CITY OF ALBUQUERQUE

Re: Albuquerque Rescue Mission, 214 Coal Ave. SW Traffic Circulation Layout Architect's Stamp dated 07-21-14 (K14-D057)

RE: Albuquerque Rescue Mission, 214 Coal Avenue SW Traffic Circulation Layout

TCL1

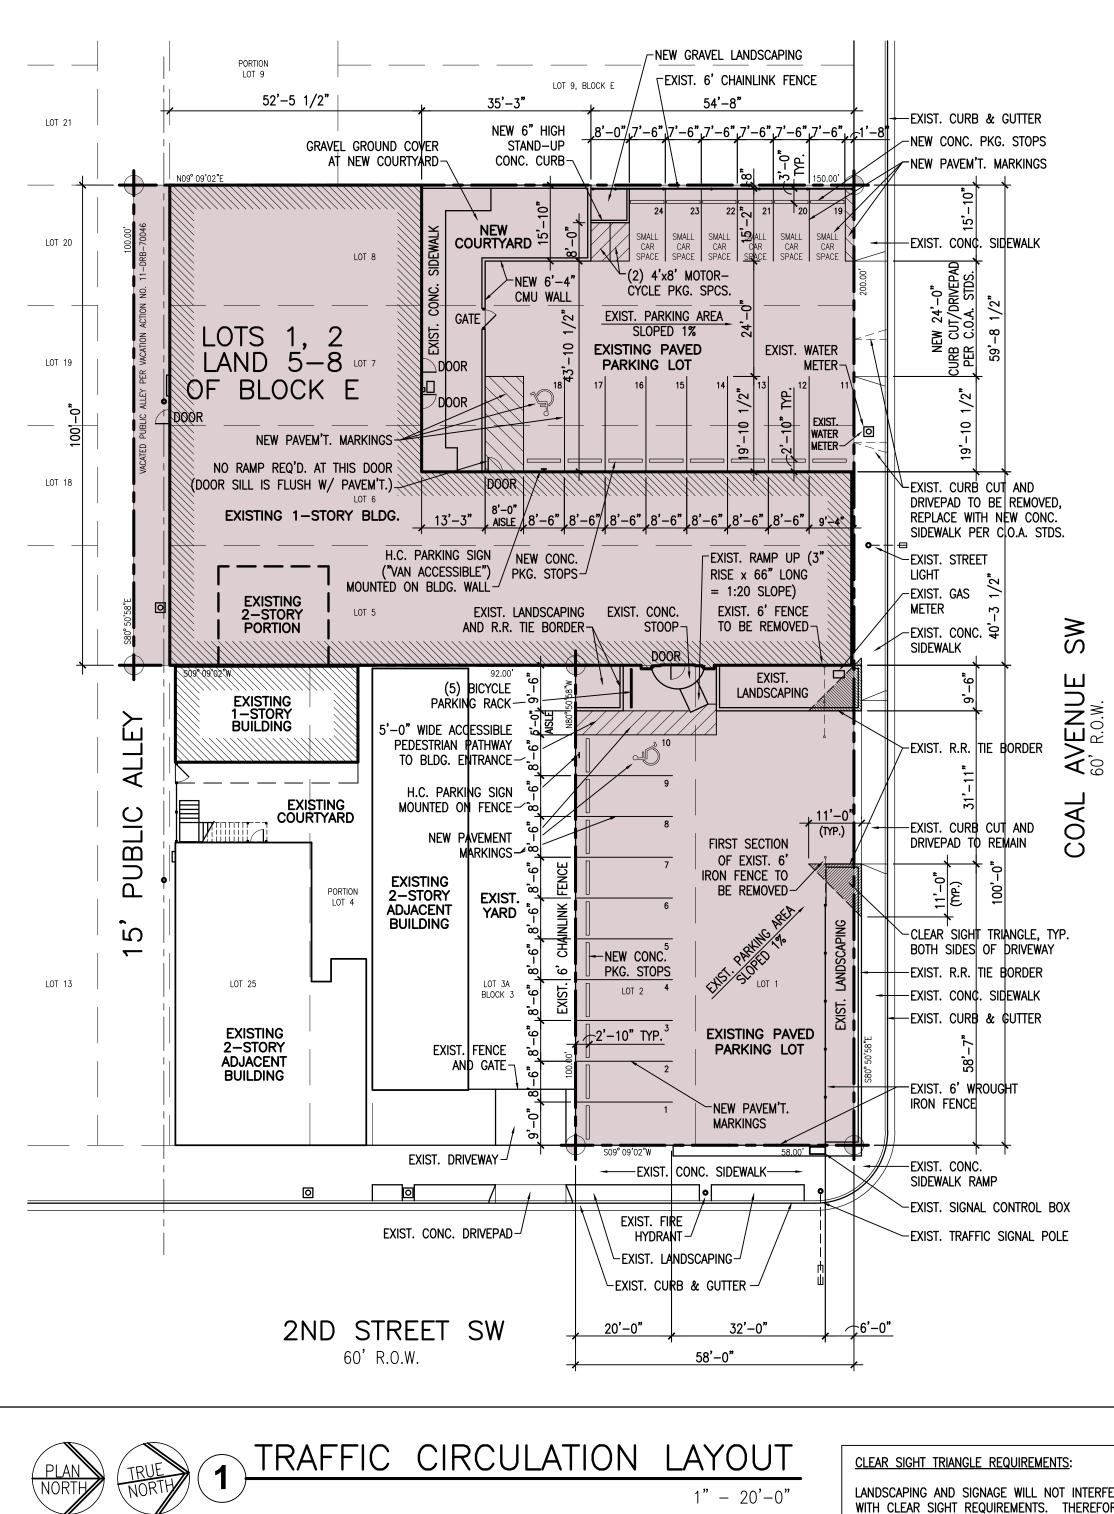
- 1. Handicapped spaces are designated with 8.5' widths. The HC space on the west side of the building includes and 8' wide van access aisle and "van accessible" sign, the HC space on the east side has a 5' aisle.

- 2. The HC space on the west side has a "van accessible" sign.
- 3. The allowable space for this parking lot remodel will allow a 5' wide ADA accessible pedestrian pathway to the building entrance, but there is not sufficient space for a 6' wide pathway.

- 4. The existing ramp on the east side is a 1:20 slope which is under the 1:12 maximum requirement. The sill of the entrance door on the west side is flush with paving outside the door, so no ramp is required at that door.

- 5. Clear sight triangles have been added to the east drive pad, and some exiting fencing is shown to be removed to meet clear sight triangle requirements.

- 6. The clear sight triangle note has been added to the TCL drawing.
- 7. Two stamped copies of the updated TCL are attached.

The TCL submittal received 07-21-14 is approved for Building Permit. A copy of the stamped and signed plan will be needed for each of the building permit plans. Please keep the original to be used for certification of the site for final C.O. for Transportation. **Public infrastructure or work done within City Right-of-Way shown on these plans is for information only and is not part of approval. A separate DRC or other appropriate permit is required to construct these items.**
